Access Compliance Report

Public Rights-of-Way

(Curb Ramps)

Intersection ID: 25053	Main Street: COTTON_CREEK_DR	Cross Street: TRUSCOTT_RD	Location: W
ADA ID: D0460FB33C13	Ramp Type: PerpDiag	Initial Pass/Fail: Fail	Overall Compliance: No
Severity Score: 35			
Codes/Mitigation Info/Possible Solution		Field Measurements/Component Compliance

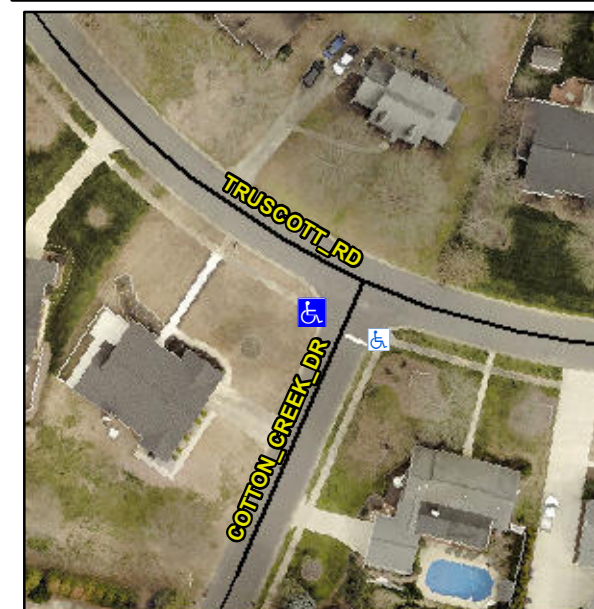
Not Found, R304.5.1, R304.2.2, R304.5.3

Compliance	Description	Data	Compliance	Description	Data
N/A	Ramp Length (in)	135.0	No	Ramp Slope (%)	12.2
No	Ramp Width (in)	47.5	No	Ramp XSlope (%)	4.0
N/A	Flare Type LT	N/A	N/A	Flare Type RT	N/A
N/A	Flare Slope LT (%)	N/A	N/A	Flare Slope RT (%)	N/A
N/A	Flare Traversable LT?	N/A	N/A	Flare Traversable RT?	N/A
N/A	Landing Length (in)	N/A	N/A	DWS Provided?	N/A
N/A	Landing Width (in)	N/A	N/A	DWS Contrast?	N/A
N/A	Landing Slope (%)	N/A	N/A	DWS Length (in)	N/A
N/A	Landing X Slope (%)	N/A	N/A	DWS Full Width?	N/A
N/A	Landing Curb? (Y/N)	N/A	N/A	DWS Offset (in)	N/A
N/A	Shared Landing?	N/A			
N/A	Gutter Ponding?	N/A	N/A	Gutter Slope (%)	N/A
N/A	Gutter Lip Ht (in)	N/A	N/A	Gutter X Slope (%)	N/A
N/A	Painted X Walk1?	No	N/A	Painted X Walk2?	No
	X Walk 1 Direction	To SE		X Walk 2 Direction	To NE
N/A	X Walk 1 Width (in)	N/A	N/A	X Walk 2 Width (in)	N/A
	X Walk 1 Slope (%)	2.1		X Walk 2 Slope (%)	6.2
	X Walk 1 X Slope (%)	6.5		X Walk 2 X Slope (%)	1.8

Remove & Replace Curb Ramp With Two New Directional Ramps or Equivalent.
